May 31, 2007

Re: Revised Standard Drawing Detail SS-4

TYPE "C" RING & COVER FOR STORM SEWERS

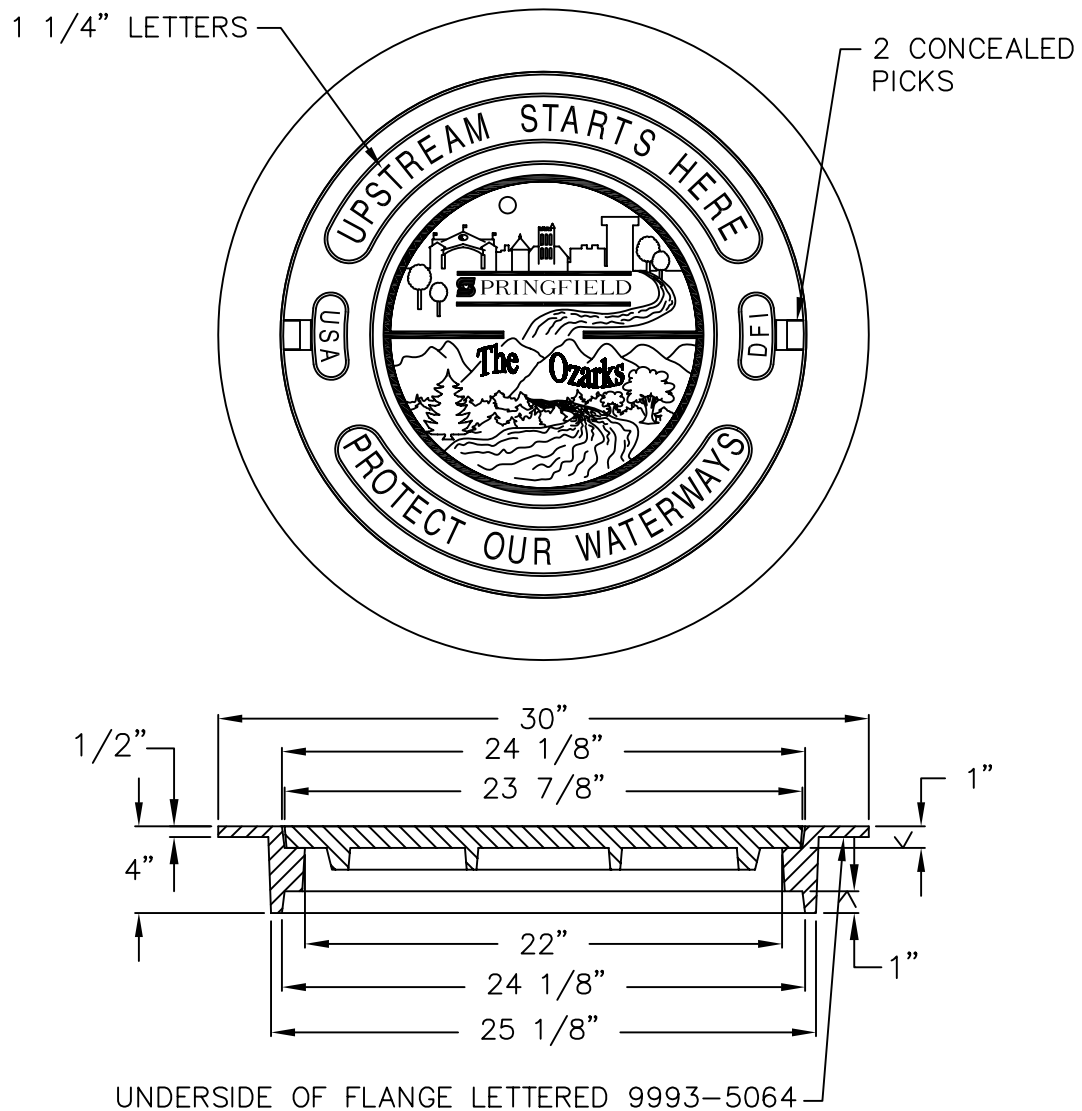
1. Drawing SS-4 Type C Ring & Cover shall be replaced with Drawing SS-4-C changing the standard to Deeter #1157 Ring w/ #2018-A Cover, East Jordan Iron Works #2425Z Ring w/ #2408A Cover or equal and incorporating on the cover the design as shown and phrases "Upstream Starts Here" and "Protect Our Waterways".
2. Drawing SS-4 Type A Ring & Cover shall be replaced with Drawing SS-4-A changing the standard to Deeter #1258 Ring & Cover, East Jordan Iron Works #2420Z Ring w/ 2408A Cover, SS-4-C installed flange down or equal and incorporating on the cover the design as shown and phrases "Upstream Starts Here" and "Protect Our Waterways".

DEETER # 1157 RING W/ #2018-A COVER, EAST JORDAN
IRON WORKS #2425Z RING W/2408A COVER OR EQUAL
